NUREG-1949, Vol. 3

Safety Evaluation Report Related to Disposal of High-Level Radioactive Wastes in a Geologic Repository at Yucca Mountain, Nevada

Volume 3:
Repository Safety After
Permanent Closure

Figure 6-1. Potential Flow Pathways in the Engineered Barrier System (SAR Figure 2.3.7-8; DOE, 2008ab)

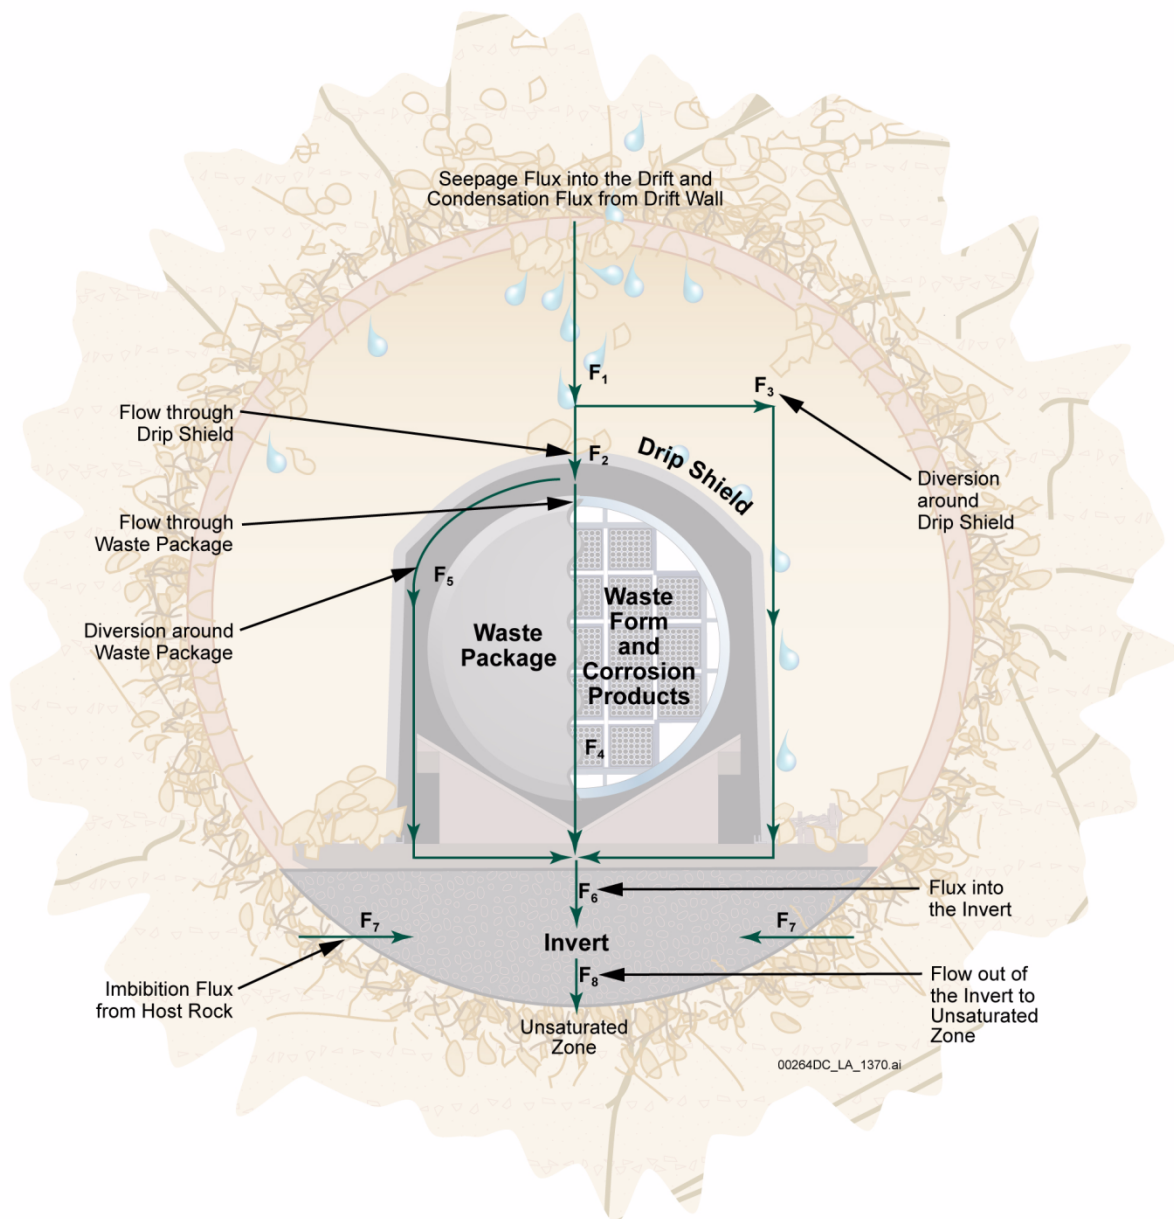
The applicant described the flow pathways and flux rates (F1–F8) in the EBS flow abstraction as follows (Figure 6-1): the F1 flow path accounts for the total dripping flux from a drift wall. The total dripping flux is the sum of the seepage flux from the drift wall above and the condensed water on drift walls (SER Section 2.2.1.3.6.3.4); these are direct inputs to the EBS flow abstraction. The F2 flow path accounts for the flux through partially failed patches of the drip shield formed by general corrosion. Localized corrosion of the drip shield is excluded from the performance assessment, as discussed in SER Section 2.2.1.2.1.3. The F3 flow path accounts for the diversion of flux around the drip shield (computed as $F3 = F1 - F2$), which will drain directly into the invert. Although the diversion of flux around the drip shield is included in the construction of the EBS flow model, the applicant did not implement the flux-splitting algorithm for drip shields in TSPA simulations, because the drip shields were modeled to be either all intact or failed, as described in SNL (2007aj, Section 6.1.1). The F4 flow path accounts for the flux through patches, formed as a result of general corrosion of the outer barrier of the waste packages. Localized corrosion of the outer barrier of waste packages is not considered
